PLACER COUNTY WATER AGENCY
SINCE 1957

SUBJECT: Comments on BDCP/CalWaterFix RDEIR/SDEIS

SUBJECT: Technical Comments on Bay-Delta Conservation Plan Modeling

Effects of Implementation of the Bay Delta Conservation Plan

Figure 7. NAA-LLT and Alt 4-LLT Simulated Nimbus Release

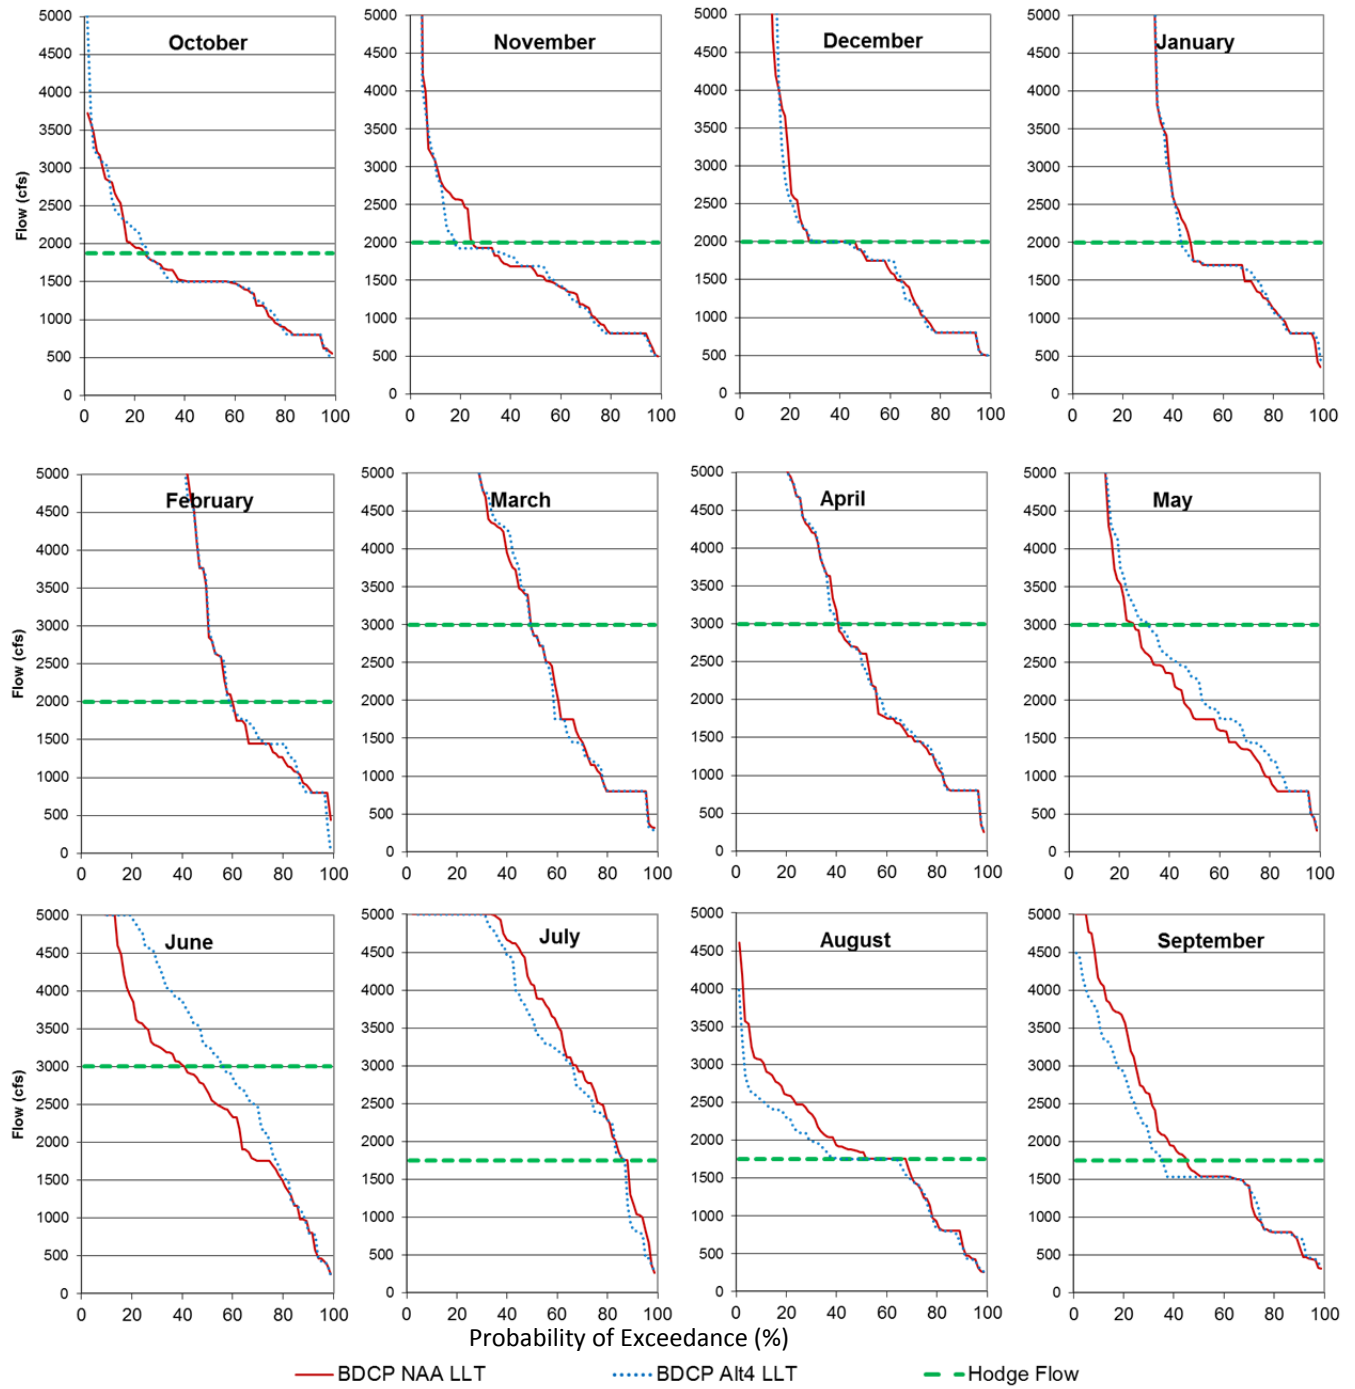
Figure 7 and Figure 8 contain comparisons of simulated monthly flow at Nimbus and H Street for the NAA-LLT and Alt4-LLT scenarios. Results show that under the Alt4-LLT American River flow is higher in the months of May and June, and lower in July, August, and September. Higher releases in May and June drive changes in Folsom storage and water surface elevation seen in previous figures. Likewise, lower releases from July through September bring simulated end-of-September storage between the baseline and with-Project scenarios closer. BDCP modeling shows a higher probability of Lower American River flows being above Hodge Flows in May and June and a higher probability of flows being below Hodge Flows in July, August, and September. When Nimbus releases are below Hodge Flows, diversion limitations under the City of Sacramento's American River water right permits for the Fairbairn Water Treatment Plant on the American River constrain the amount of water available to divert. The changes in American River flows will affect the location of the City of Sacramento's diversion, but this is not reflected in the BDCP modeling. There are also limitations on the City's Sacramento River diversion capability, which could interfere with any such shift in the location of diversions, and hence reduce the supply available to the City. This is not reflected in the BDCP modeling. In the Alt 4-LLT the City of Sacramento will be able to divert more water from the American River at Fairbairn during May and June and less during August and September.

The change in timing of release from Folsom Reservoir is caused in the Alt 4-LLT by BDCP using of different assumptions for balancing reservoirs upstream of the Delta with San Luis Reservoir in Alt 4-LLT relative to assumptions in the NAA. In other words, the BDCP operations triggered changes in the timing of Folsom Reservoir releases. These balancing rules attempt to move more water into San Luis Reservoir earlier in the year in the with-Project scenario. It is unclear why BDCP modeling changed these assumptions to simulate Project alternatives.

Figure 8. NAA-LLT and Alt 4-LLT Simulated H Street Flow

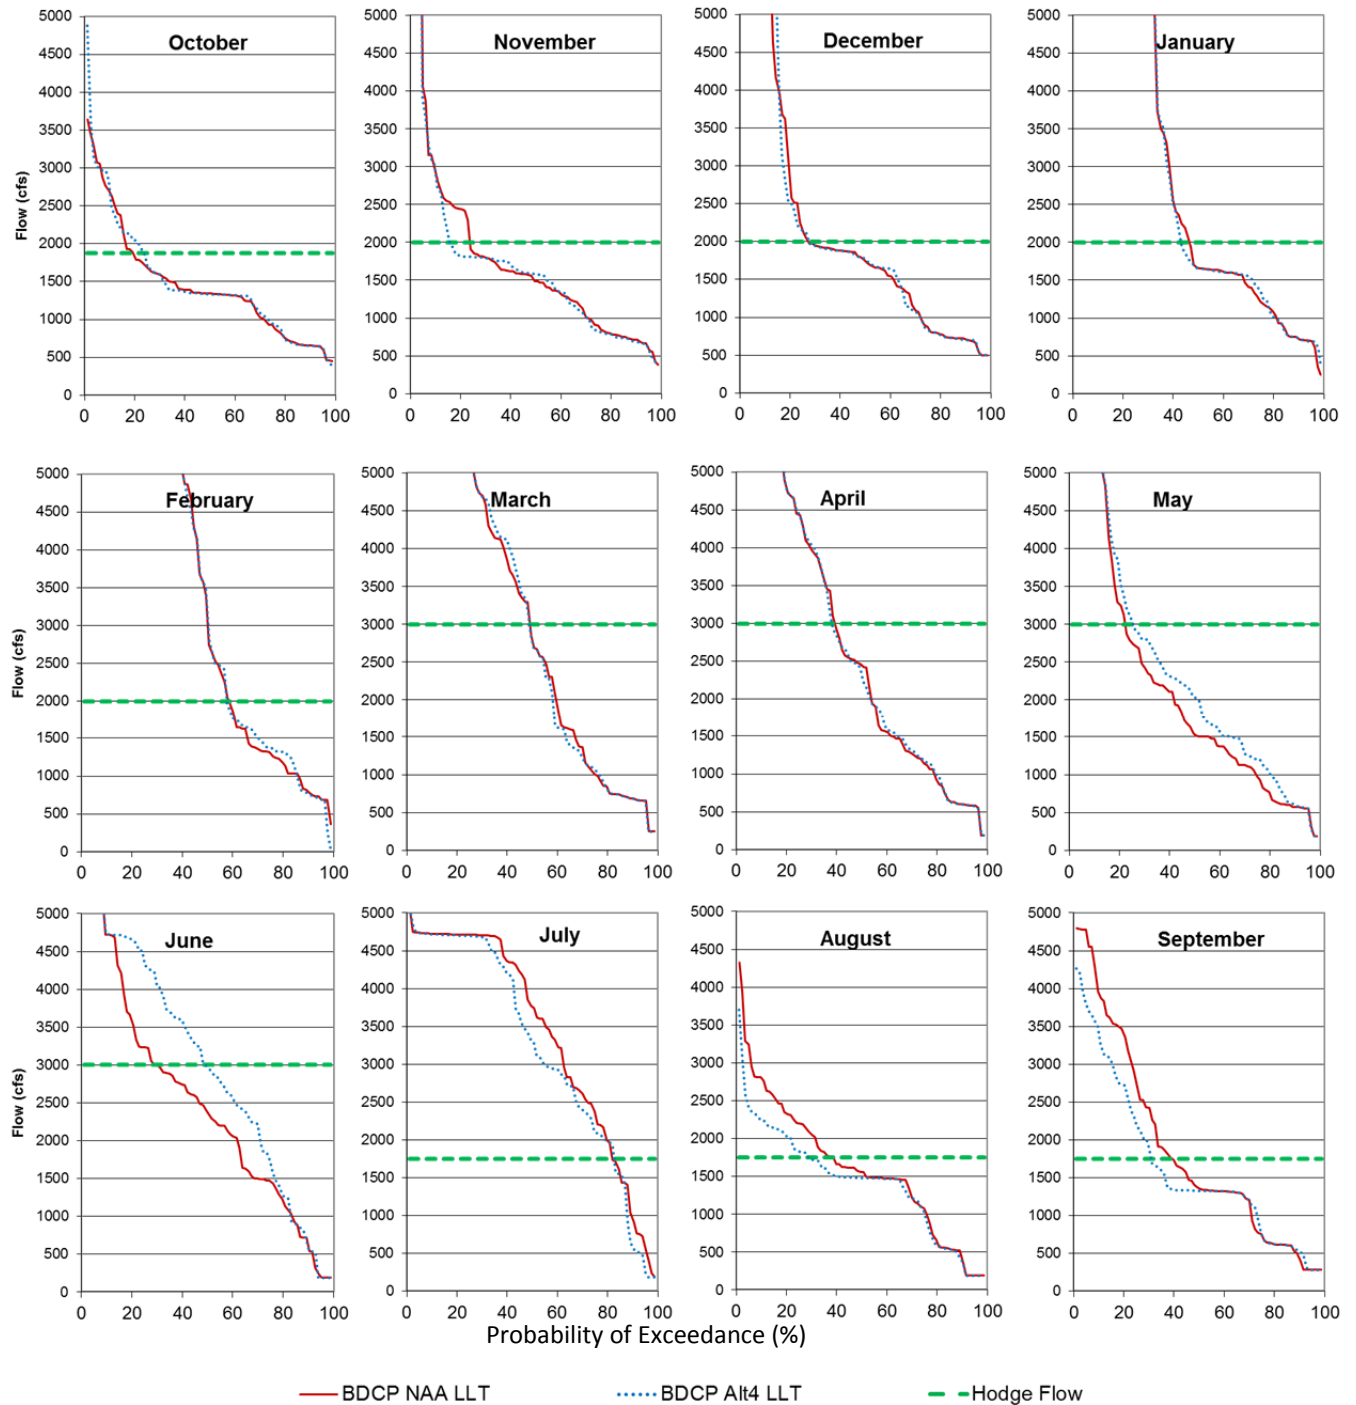
Flow in the lower American River at H Street drops below 500 cfs in both the NAA-LLT and Alt4-LLT. This is critical for the City of Sacramento because their ability to divert water from the American River is affected when flow at H Street falls below 500 cfs due to the potential for pump cavitation. There are times when American River at H Street falls below 500 cfs more often in Alt 4-LLT than in the NAA-LLT. Water availability to the City of Sacramento, including under its settlement contract with Reclamation¹⁴, would be curtailed or eliminated on the American River when water levels in Folsom Reservoir drop below to dead pool level of 90,000 AF.

Figure 9. NAA-LLT and Alt 4-LLT Simulated Sacramento River Flow at the American River

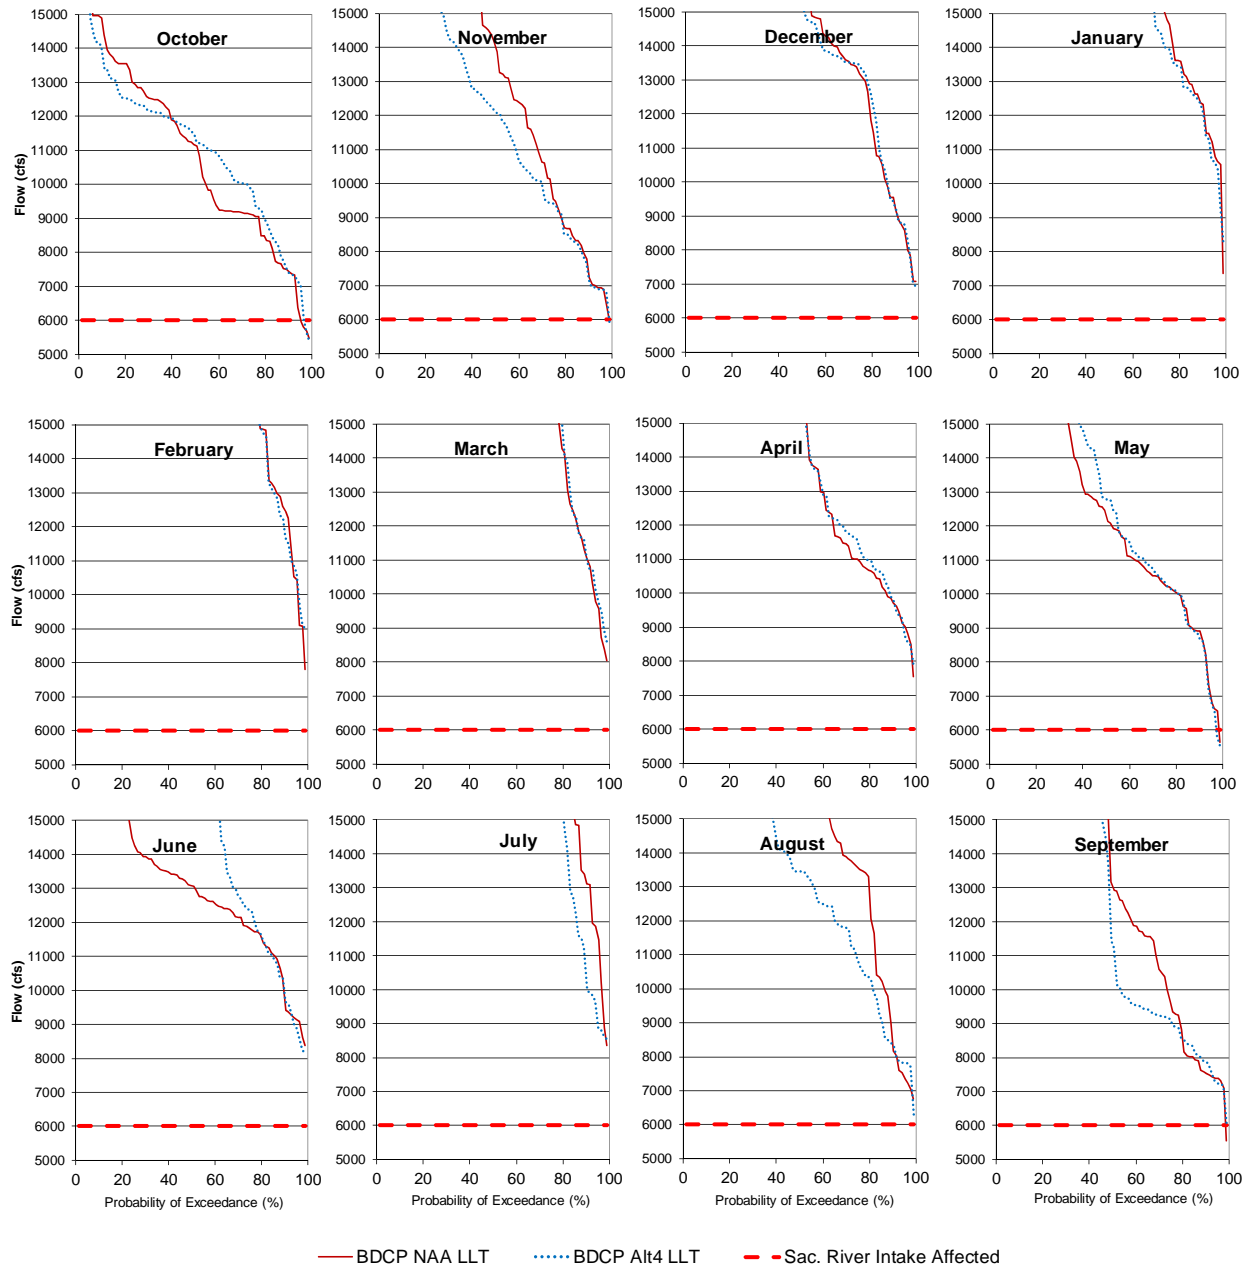
Figure 9 contains comparisons of simulated monthly flow in the Sacramento River at the confluence of the American River for the NAA-LLT and Alt4-LLT scenarios. When Sacramento River elevation falls below two feet above sea level (NGVD 1929) the City of Sacramento's intake structure capacity is reduced. Elevation 2.0 occurs when the flow rate is between approximately 5,000 cfs and 9,000 cfs and depends on tidal variation. Moreover, flow rates below 5,000 cfs may result in cavitation or vortexing, causing significant pump damage. Based on CalSim II modeling results, the frequency of the Sacramento River falling below 6,000 cfs is similar in the NAA-LLT and Alt4-LLT.

Figure 10. CVP North of Delta M&I Water Service Contract Allocation

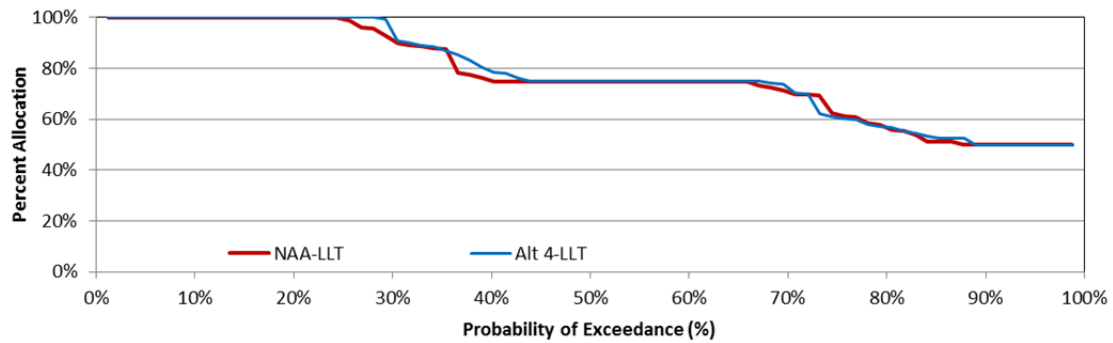
Figure 10 is an exceedance probability plot of CVP North of Delta M&I Water Service Contract Allocation for the NAA-LLT and Alt4-LLT. Changes in these allocations would affect the numerous CVP water-service contractors in the American River Basin, including the cities of Folsom and Roseville, Placer County Water Agency, SMUD and Sacramento County Water Agency. Average annual allocation to CVP M&I water service contractors is about 78% and increases by about one half of one percent in Alt 4-LLT compared to NAA-LLT. Although allocation never falls below 50%, deliveries are not always met due to low reservoir and river flows

Figure 5a. Summer (July - October) Monthly Mean End-of-Month of Storage Folsom Reservoir Storage (TAF) under the Existing Condition, No Action Alternative, and Preferred Alternative (Alternative 4).

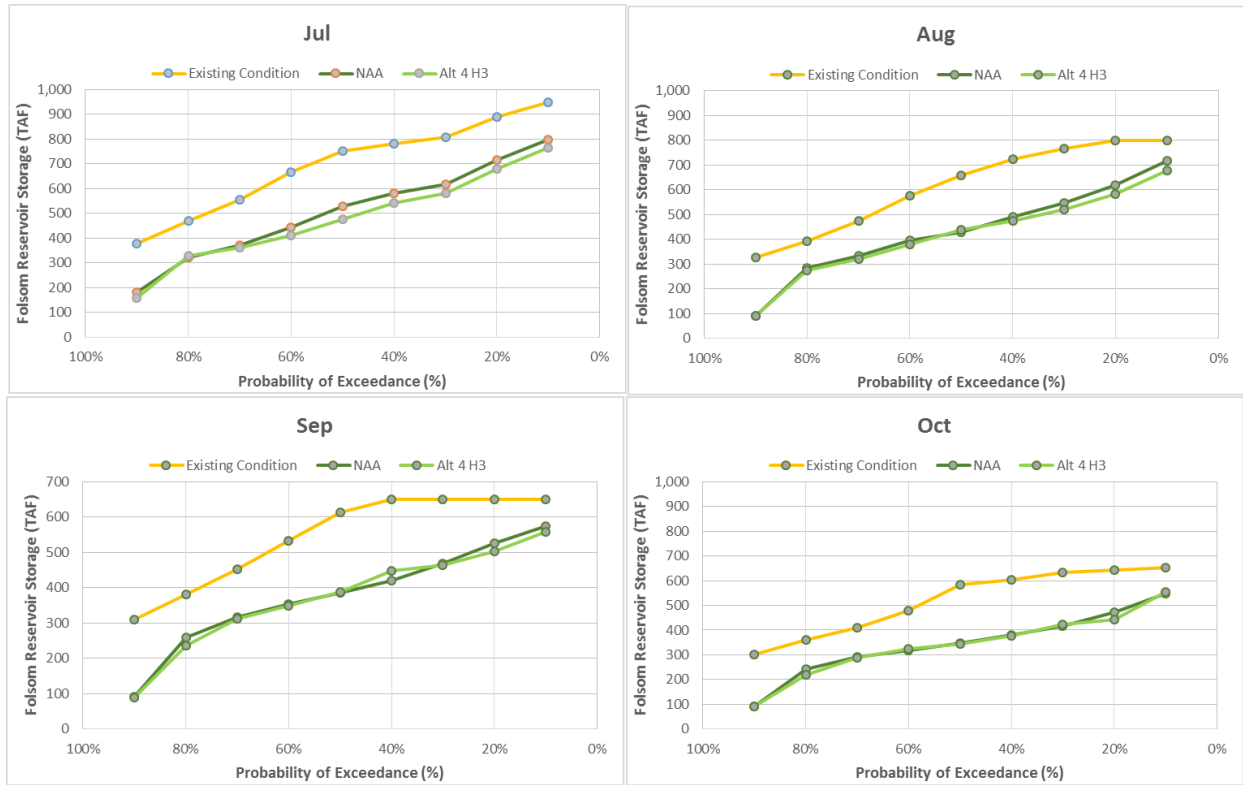
The operation of the CVP/SWP as modeled in the NAA with the sea level rise, climate change, and future demand assumptions results in much lower Folsom Reservoir storage elevations compared to existing conditions (Figures 5a and b) and greatly increased LAR water temperature. The frequency of Folsom Reservoir being at low storage levels (e.g., <350 thousand acre-feet [TAF]) would increase substantially in July and August under the NAA compared to existing conditions (increases from about 10% of the time under existing conditions to about 30% of the time under the NAA) (Figure 5a). In critical years, mean monthly

Folsom Reservoir storage would be 119 TAF, 105 TAF, and 81 TAF lower in July, August, and September, respectively, than under existing conditions (down to 210 TAF, 165 TAF, and 159 TAF, respectively, under the NAA). Mean monthly storage in drier years would drop to less than 350 TAF in August and September under the NAA (>440 TAF under existing conditions) (Figure 5b). Further, the frequency of which Folsom Reservoir would be drained to dead pool storage would increase by about 10% (DWR et al. 2013; p. 5-61). This would result in greatly increased water temperatures in the LAR.

Figure 6. Folsom Reservoir Storage (TAF) in Relation to ATSP Temperature Schedule¹. Higher ATSP Schedules Correspond to Warmer Summer Temperatures. All Schedules Larger than 55 Exceed Summer Temperatures of 70°F.

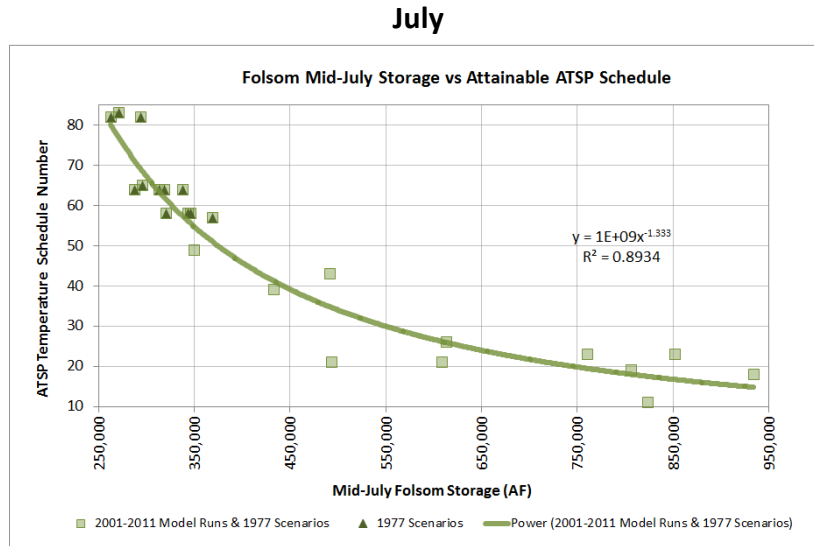
Higher American River summer temperature schedules occur when Folsom Reservoir storage drops, particularly as storage falls below 350 TAF in July. Figure 6 shows a relationship between the Folsom Reservoir storage in July and LAR water temperature schedules². Figure 7 shows relatively large increases in fall water temperature below Nimbus Dam at low Folsom Reservoir water levels as reported in the BDCP EIR/EIS (and the associated Folsom Reservoir storage) under the NAA operations. These changes are most pronounced in drier years.
